GFA AD 408

GFA AIRWORTHINESS DIRECTIVE

TYPE AFFECTED: Grob G 109B from serial number 6200.

SUBJECT: Drain holes in the elevator and trim tab.

Service Bulletin
TM 817-35

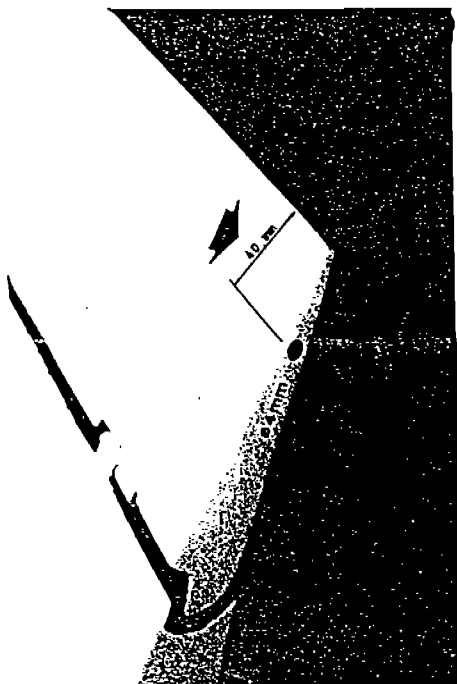
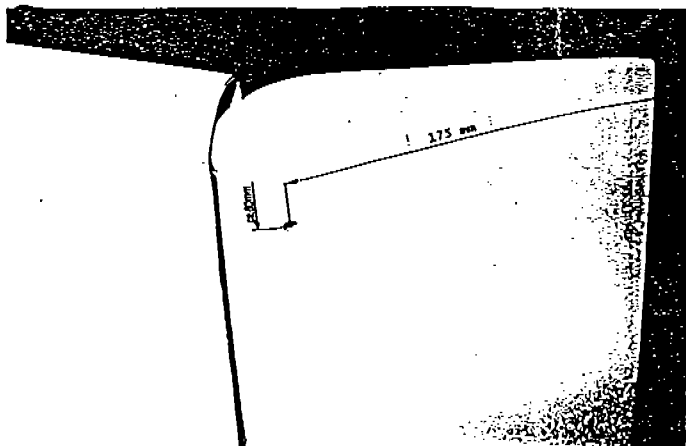
6 ϕ 4 mm

7 ϕ 4 mm

8 ϕ 4 mm

25 mm

25 mm

LUFT- UND RAUMFAHRT	Service Bulletin TM 817-35	GROB G 109B
Subject: Inspection of drain holes in the elevator (including trim tab) Concerning: G 109B, as of S/N 6200 Urgency: 31 October 1992 at the latest Procedure: A sufficient number of drain holes must be provided in the elevator including trim tab. Otherwise the laminate can be damaged by the water penetration, or weight and C.G. problems of the elevator may occur, and cause at the worst flutter tendency. Actions: The following inspections must be performed: 1. Check for provided and open drain holes at the following positions (quantity: 8): <u>Elevator bottom side</u>  If drain holes are provided at these positions, check whether they are open. If so, no further action is required. 2. If drain holes are not provided at these positions, drill drain holes of ϕ 6 mm or ϕ 4 mm according to the figures shown on pages 3 and 4. Caution: Before drilling it is helpful to remove the horizontal tail according to the Flight Manual. While drilling take care not to damage the upper elevator shell!

Service Bulletin
TM 817-35

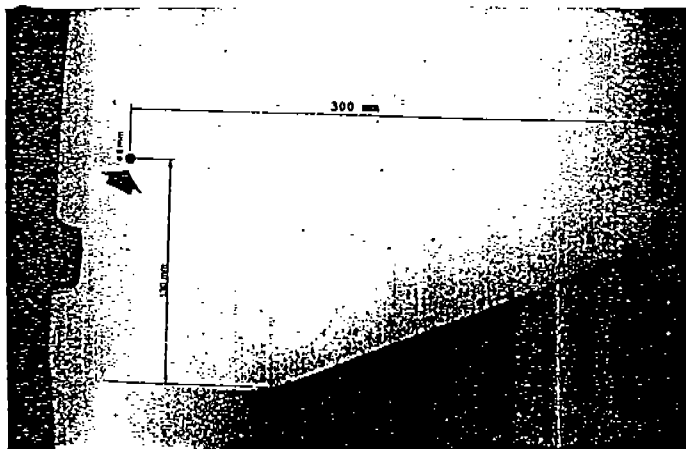
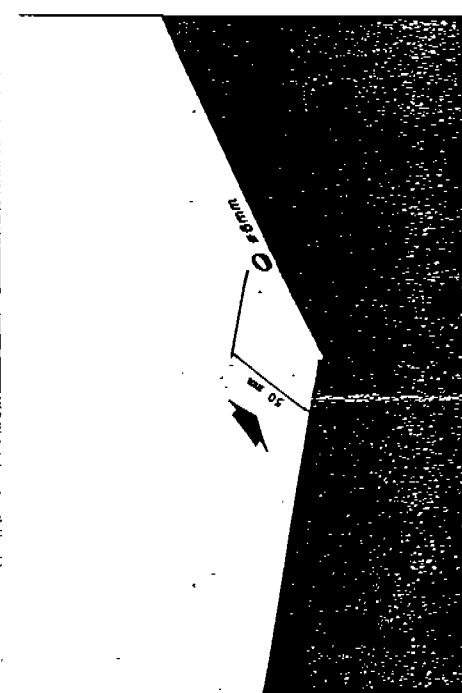
1, 4 ϕ 6 mm

2, 3 ϕ 6 mm

5 ϕ 6 mm
